**Comanche Peak Nuclear Power Plant, Units 3 & 4
COL Application**

FSAR Revision 3

Update Tracking Report

Revision 1

Figure 2.5.1-213 Significant Quaternary Features Outside of the Site Region

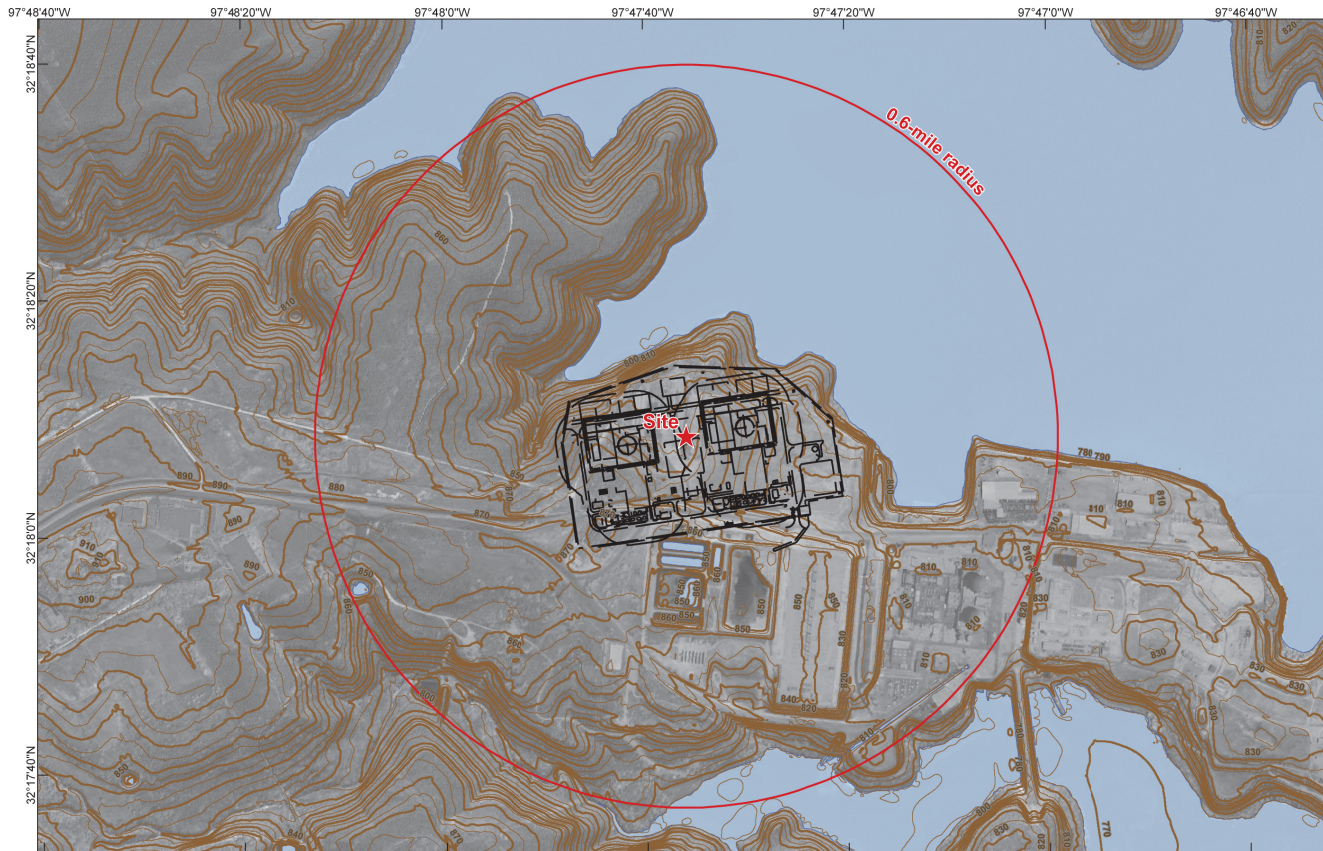
The Cheraw fault is located in southeastern Colorado over 500 mi from the site (Figure 2.5.1-213). The potential for Quaternary events on the fault was first noted by Scott (Reference 2.5-322) and three Late Quaternary events were dated by Crone, et al. (Reference 2.5-323). The fault is included in this discussion because, despite its great distance from the site, it is one of the closest capable faults to the site. The Cheraw fault is structurally positioned above and between the Las Animas Arch, an approximately 200-mi-long arch in Precambrian crystalline rocks, and the Denver Basin, a complementary basement low to the northwest of the arch (References 2.5-324 and 2.5-325). Offset across the fault is concordant with the offset in the basement surface between the arch and basin, down to the northwest, but the fault is not observed to offset the basement surface (Reference 2.5-324). Fault offsets across buried bedrock horizons are on the order of tens to hundreds of ft, and fault offsets of Quaternary deposits are only 20~~3~~ to 26 ft (References 2.5-323 and 2.5-326). These observations suggest that the fault has not had a long history of movement (millions of years).

The ~~New Madrid Seismic Zone (NMSZ)~~ extends from southeastern Missouri to southwestern Tennessee and is located approximately 500 mi northeast of the site (Figure 2.5.1-213). ~~The NMSZ~~ lies within the Reelfoot rift and is defined by post-Eocene to Quaternary faulting with previous older seismic activity. Given its significant distance from the site, the ~~NMFS NMSZ~~ did not contribute to the seismic hazard calculated ~~by the Electric Power Research Institute Seismicity Owners Group (EPRI-SOG)~~ for CPNPP Units 1 and 2 (Reference 2.5-327). However, the ~~NMFS NMSZ~~ needs to be reconsidered for CPNPP Units 3 and 4 because several more recent studies provide significant new information regarding characterization of the seismic capability of the ~~NMFS NMSZ~~. | CTS-01521

Figure 2.5.1-230 1949 Historical Photograph

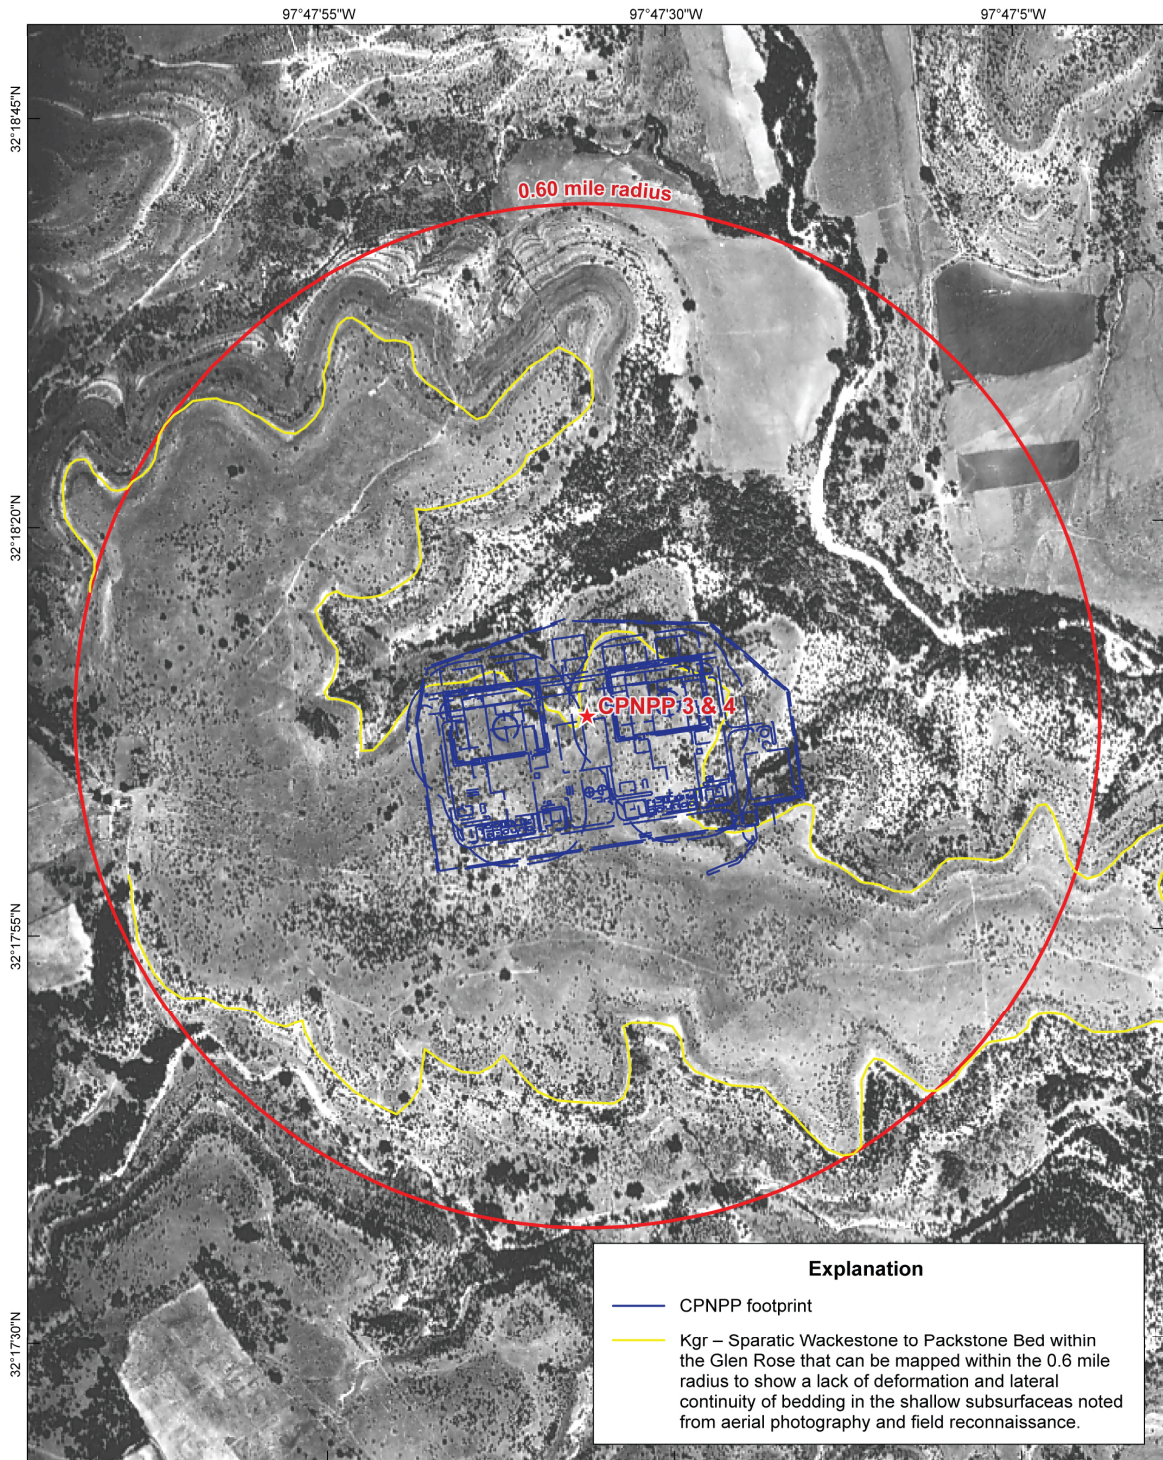
CTS-01521

Figure 8.2-207 Unit 3 Unit Switchyard Layout

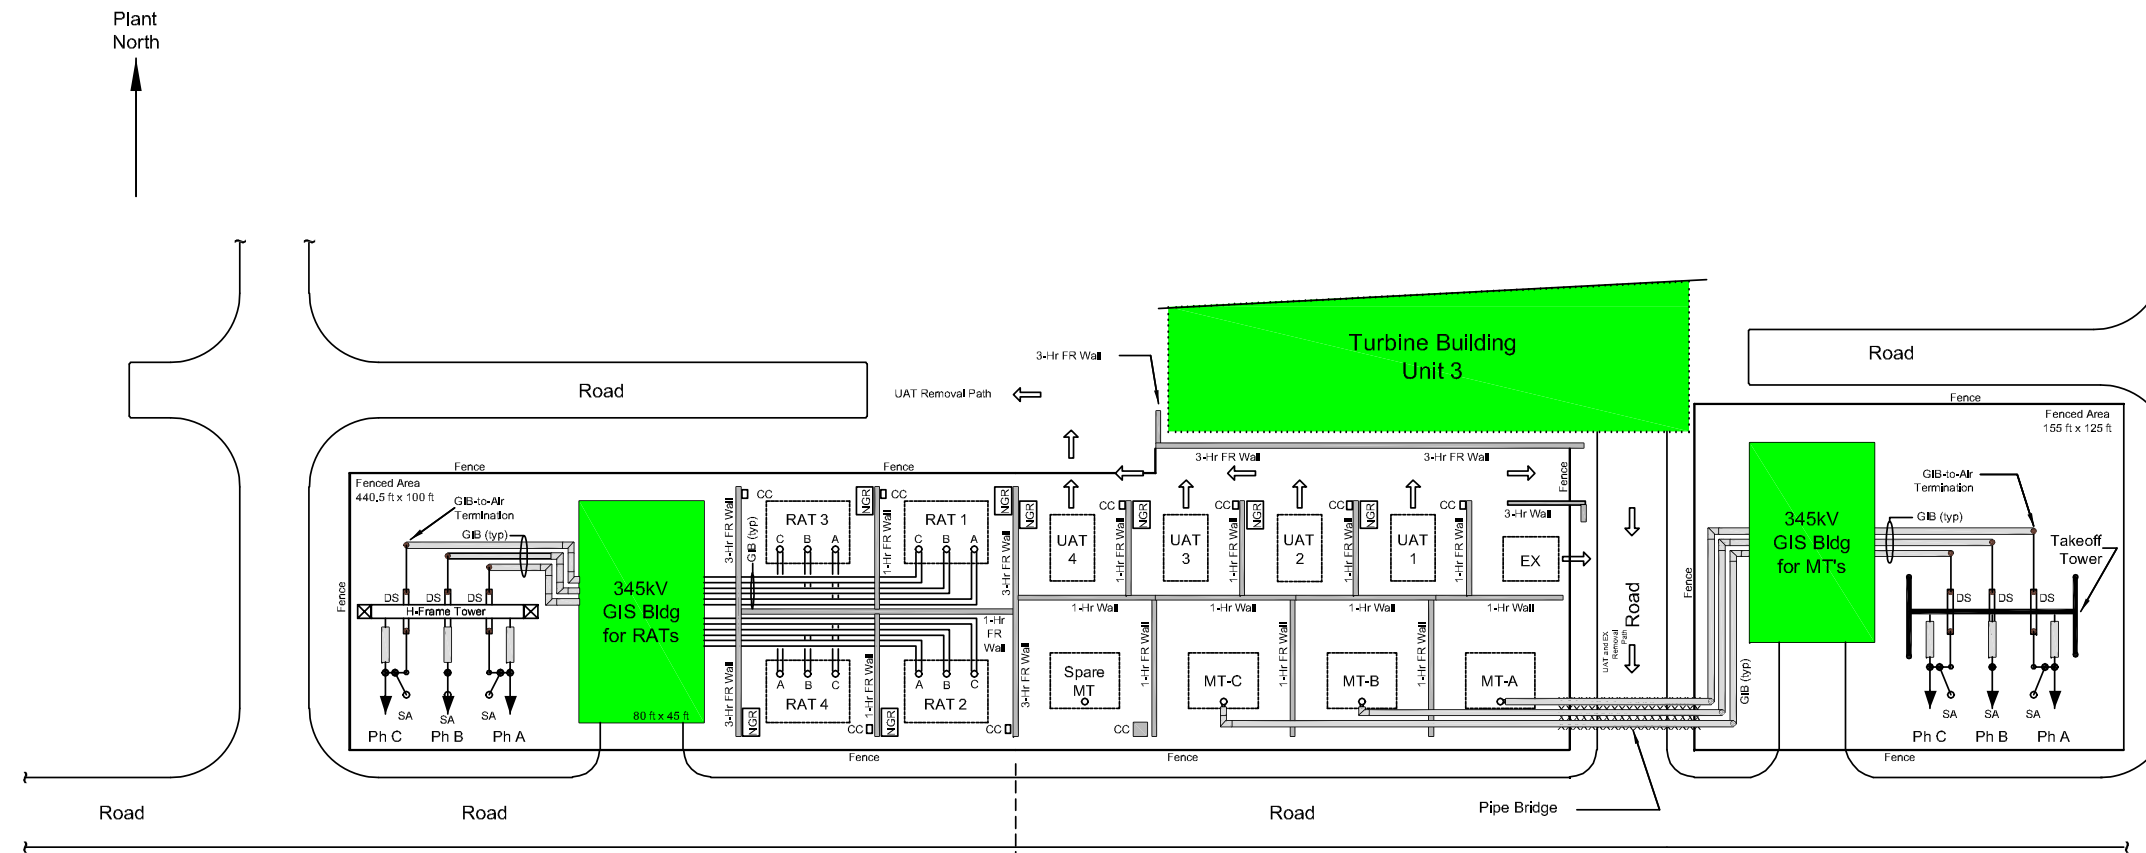
CTS-01508
